PRE-APPLICATION ADVICE

Location: Land adjacent to 3 Brickfield Cottages, East Cowes Road, PO32 6NH

Proposal: Detached dwelling

Plan no. PL02-003 Rev. C

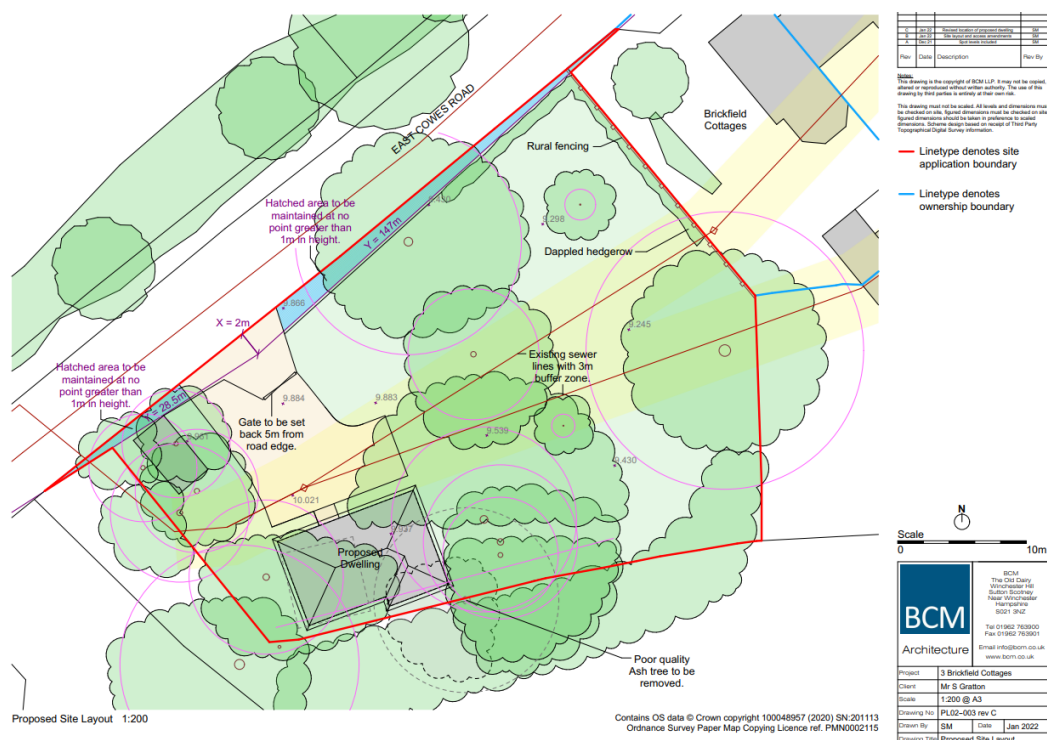
The development / dwelling hereby approved shall not be occupied / brought into use until sight lines have been provided in accordance with the visibility splays shown on the approved plan PL02-003 Rev. C, dated January 2022. Nothing that may cause an obstruction to visibility when taken at a height of 1.0m above the adjacent carriageway / public highway shall at any time be placed or be permitted to remain within that visibility splay.

The development / dwelling hereby approved shall not be occupied / brought into use until the means of vehicular access thereto has been constructed and drained in accordance with details to be submitted and approved in writing by the Local Planning Authority based on the layout as detailed on drawing number PL02-003 Rev. C, dated January 2022.

Notwithstanding the provisions of the Town and Country Planning (General Permitted Development) (England) Order 2015 (or any Order revoking and re-enacting that Order with or without modification), no gates shall be erected other than those expressly authorised by this permission/other than gates that are set back a minimum distance of 5.0 metres from the edge of the carriageway of the adjoining highway and open into the site only.

Plan PL02-003 Rev. D

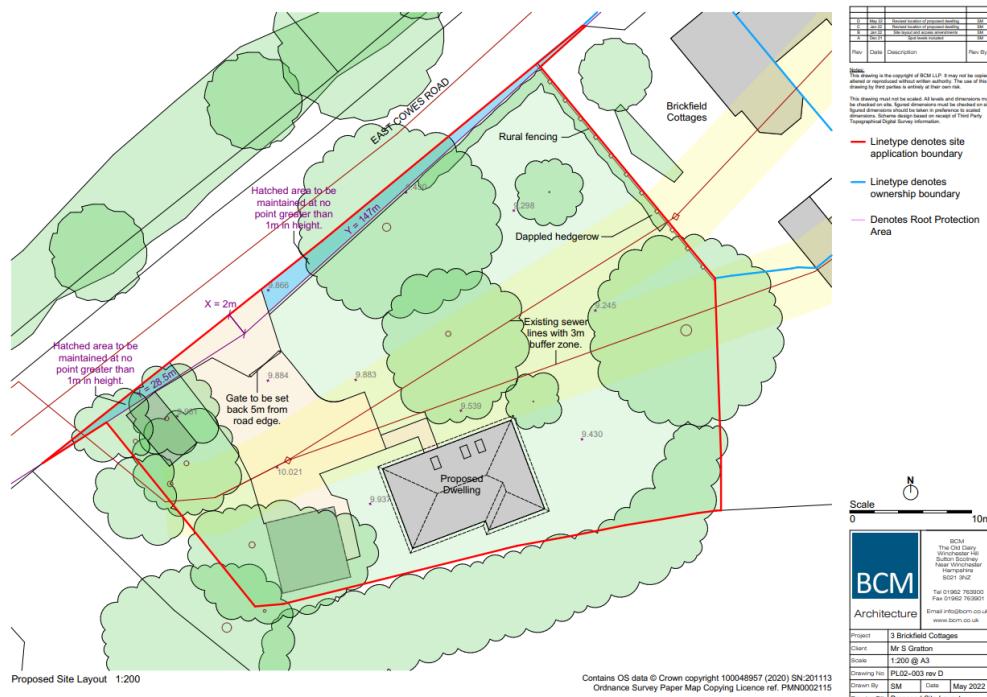
The dwelling hereby approved shall not be brought into use until sight lines have been provided in accordance with the visibility splays shown on the approved plan PL02-003 Rev. D, dated May 2022. Nothing that may cause an obstruction to visibility when taken at a height of 1.0m above the adjacent carriageway / public highway shall at any time be placed or be permitted to remain within that visibility splay.

The dwelling hereby approved shall not be brought into use until the means of vehicular access thereto has been constructed and drained in accordance with details to be submitted and approved in writing by the Local Planning Authority based on the layout as detailed on drawing number PL02-003 Rev. D, dated May 2022.

Notwithstanding the provisions of the Town and Country Planning (General Permitted Development) (England) Order 2015 (or any Order revoking and re-enacting that Order with or without modification), no gates shall be erected other than those expressly authorised by this permission/other than gates that are set back a minimum distance of 5.0 metres from the edge of the carriageway of the adjoining highway and open into the site only.
